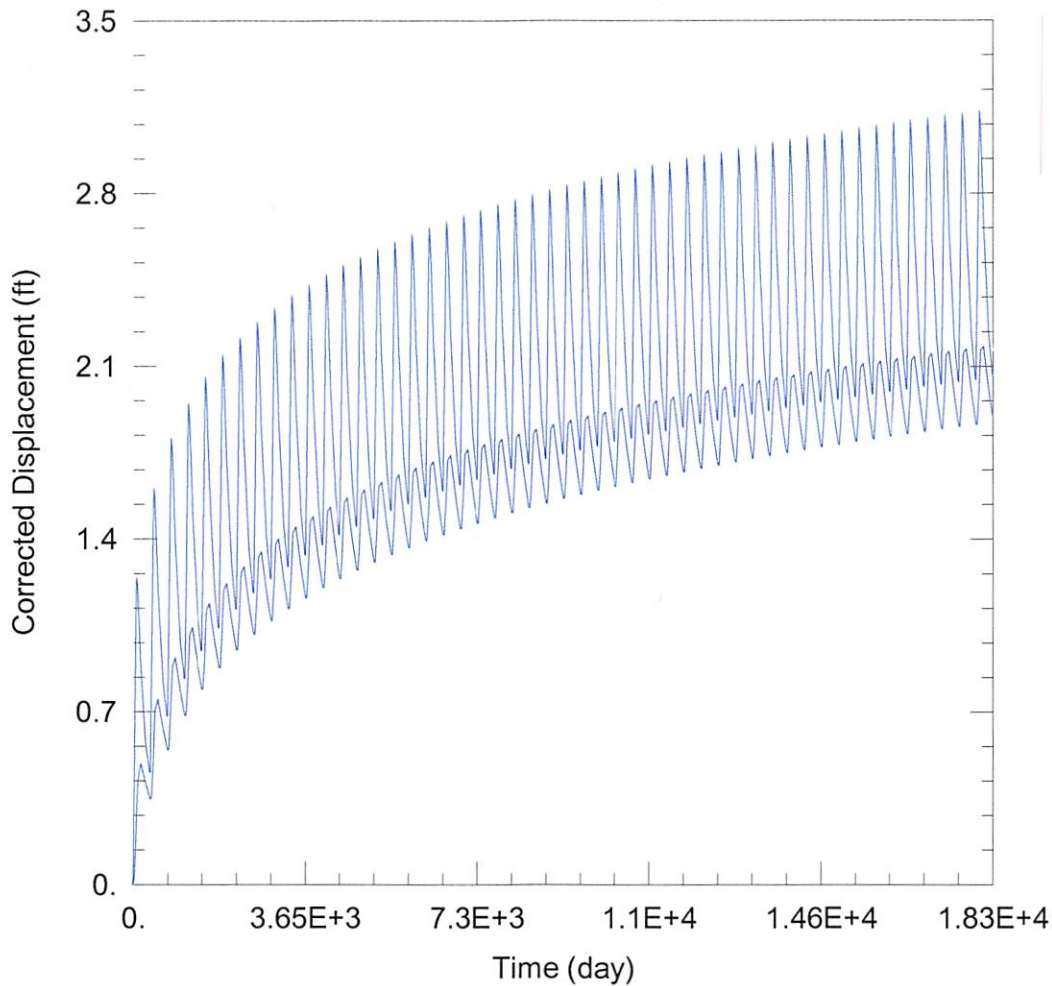
Net drawdown does not exceed the drawdown allowance of 3.0 ft for any wells within 1 mile of the proposed location. Therefore, critical well analysis is not necessary.

Based upon information from the GMD3 model, this proposal will cause minimal effects on neighboring wells, and is unlikely to create an impairment. GMD3 staff recommends approval of the application.
